POWER PLANT - EGT AND FIREWIRE HARNESS - INTRODUCTION OF LONGER BOLT AT CLIPPING POINT
7800 - CATEGORY CODE 6 - MOD.ENG-71-0161

V2500-ENG-71-0161

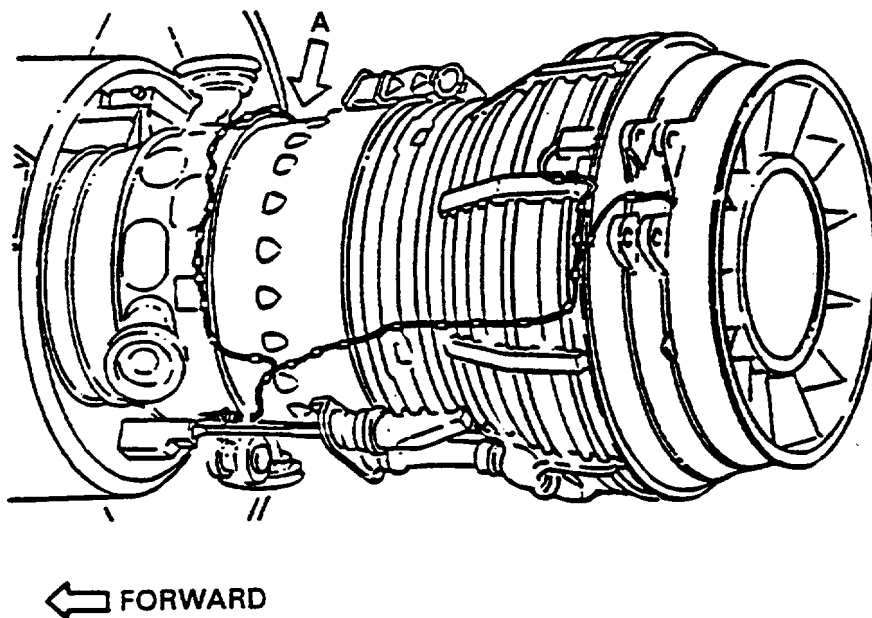
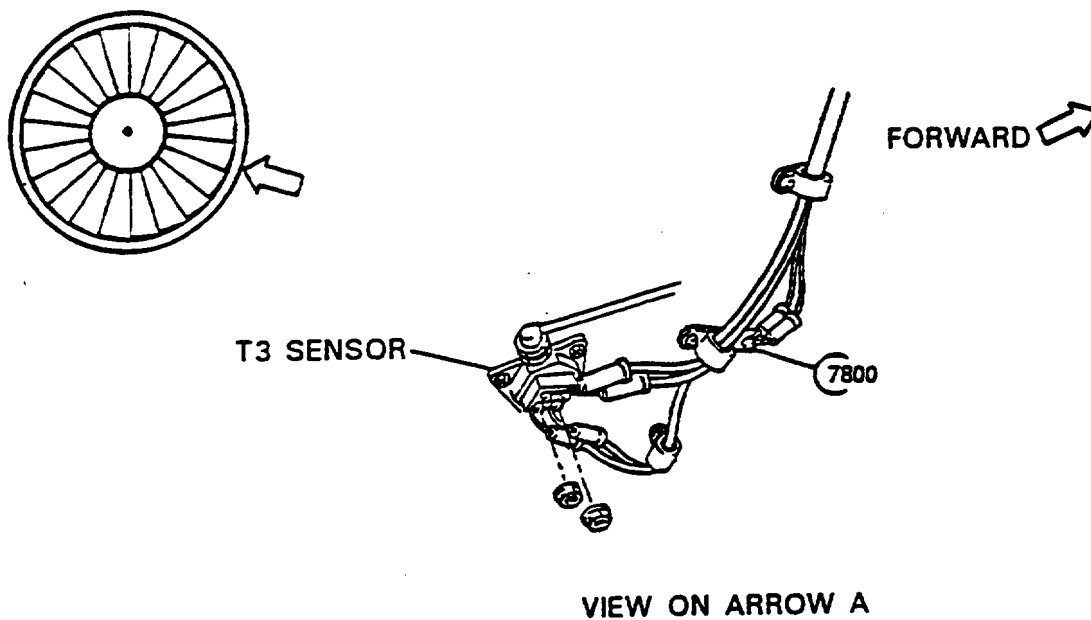
A longer bolt replaces the existing bolt at clipping point 7800.

- (1) Remove the 4W0001 nut and 4W0107 bolt from clipping point 7800. Refer to Figures 1 and 2.

- (1) Assemble existing clipping point 7800. Refer to Figures 1 and 2.

Clipping Point 7800 Flange 'FK' Bolt Nos 3 & 4
Fig.2

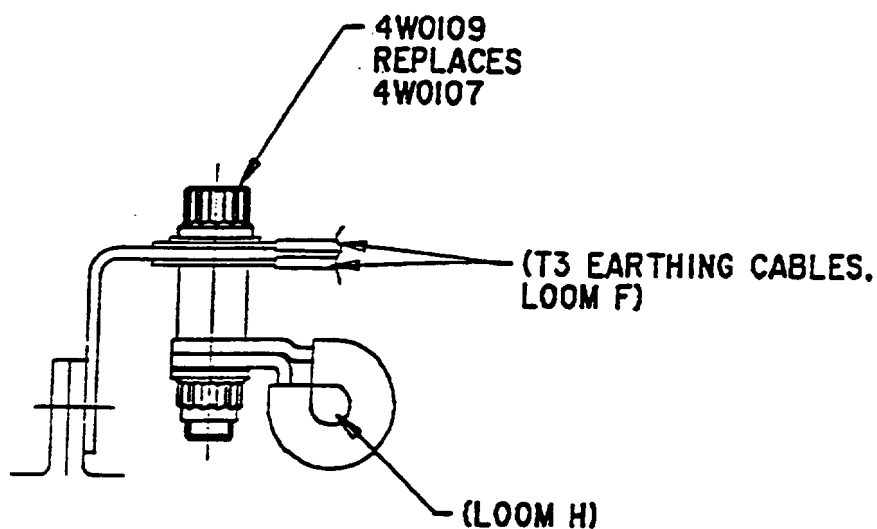
Incorrect thread protrusion of bolt at clipping point 7800.

During assembly it was highlighted that the bolt currently installed at clipping point 7800 is too short to make sure there is correct thread protrusion.

- (2) Make a clean lint free cloth moist with V01-002 cleaning fluid, use the cloth to clean the mating face of the new 4W0109 bolt and all mating faces of existing parts of clipping point 7800.
- (3) Install the new 4W0109 bolt and existing parts of clipping point 7800.
- (4) Torque the nut to 36 to 45 lbfin (4 to 5Nm).
